To: Zoe Avery - The Urbanist
From: Zibo Yang - Crang Consulting
cc: Hari Hari - Goodland
Date: August 26, 2024
Re: 2127 Kaipara Coast Highway – Formal S92 Response – Rev 1

Abib (Oamaru) Ltd (the applicant) has submitted a Resource Consent application (BUN60406128) for a subdivision proposed at 2127 Kaipara Coast Highway, Kakanui. Auckland Council have requested further information in a Section 92 (S92) letter dated 27 June 2024. This memorandum has been prepared by Crang Consulting to address queries relating to civil engineering matters. All other queries will be responded to by the relevant specialists.

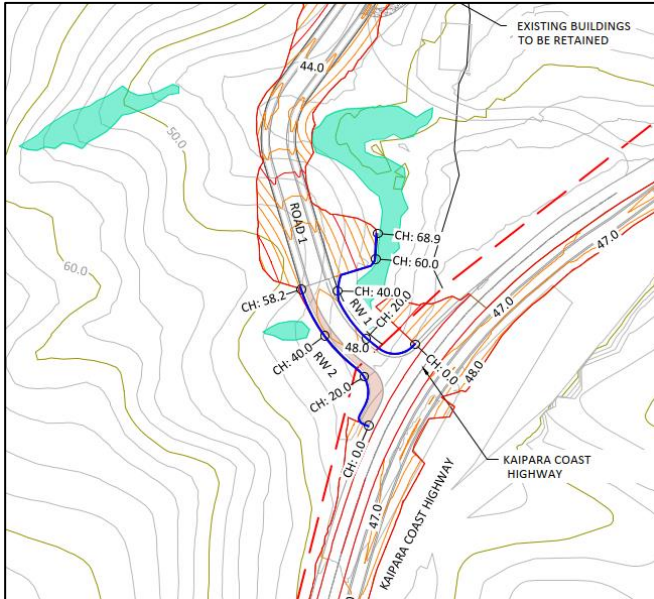
Query No.2: *Thank you for the letter from NZTA dated 30/4/2024. The letter refers to the retaining wall associated with the new vehicle crossing not being provided to date to NZTA and not included in the Geotechnical Investigation Report. Can you please clarify what is proposed, what plans show what is proposed and what investigations have been undertaken in relation to the retaining wall highlighted by NZTA.*

The retaining walls associated with the new vehicle crossing are detailed in civil drawings C201 and C240, and labeled/named as Retaining wall 1 (RW 1) and Retaining wall 2 (RW 2), see snip below. The design indicates the required retaining heights to form the new vehicle crossing in cross-sections. NZTA has reviewed and approved the design with a condition to assess the detailed design prior to installation.

RETAINING WALL 1
SCALE 1H:2V

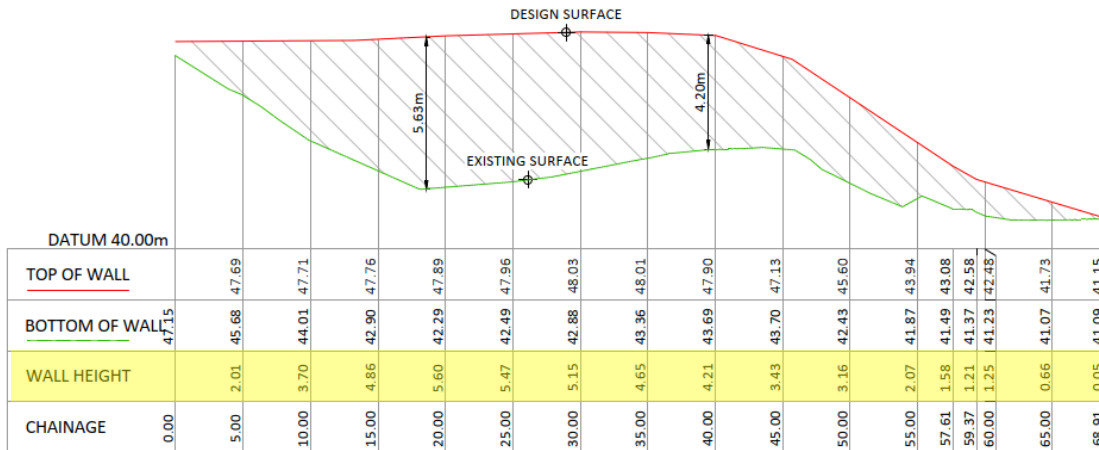
Query No. 20: Please clearly identify on a plan what sections of the walls/ fencing meet the definition of building, the total height and appearance, and provide the relevant assessment under H19.

Please refer to civil drawings C240 to 242 for the proposed retaining wall heights, an example of where to locate this information is given in the snip below (yellow highlights). Kindly note that retaining walls that are up to 3 meters high in a rural zone do not require building consent under section 13.3 support structure of the building regulation, although they might fall under the definition of building under the AUP.

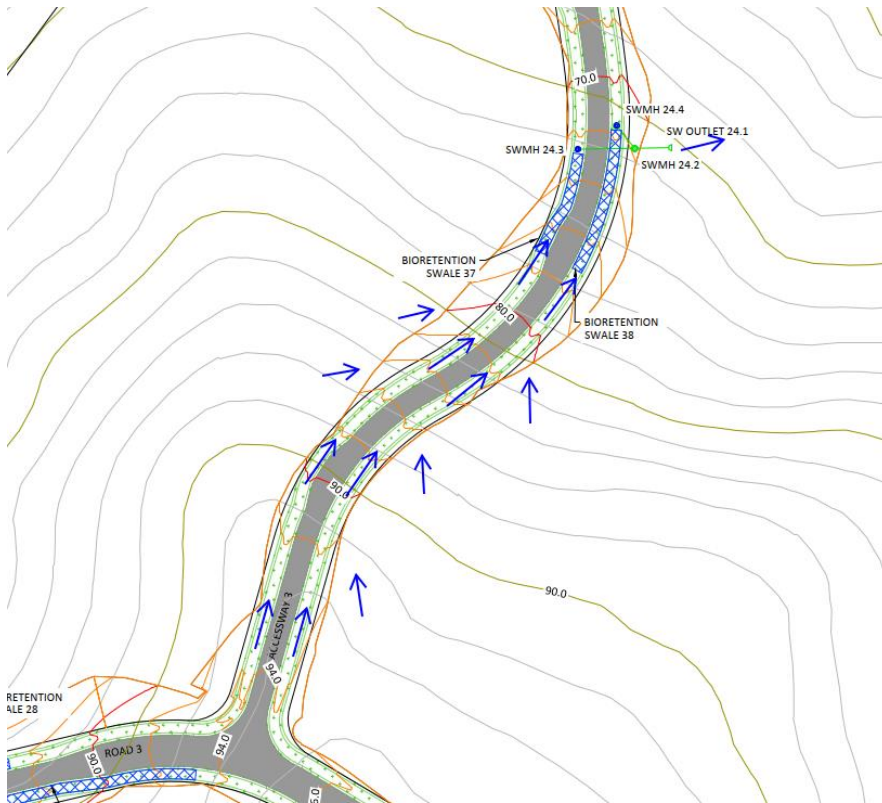
Query No. 3: *The response is not consistent with roading typical cross sections. Please identify the areas where road is not built on ridge line and explain the influence on road drainage system due to runoff from additional catchment.*

For design of the roading drainage system roading, please refer to the typical cross section plans in conjunction with the drainage plans (i.e. C400 series). Where the roads/accessways are not proposed entirely along ridge lines, stormwater runoff from the adjacent catchments will be collected via the table drain on either side of the road and discharged through an outlet pipe. Snip below uses accessway 3 as an example, where blue arrows represent indicative flow direction.
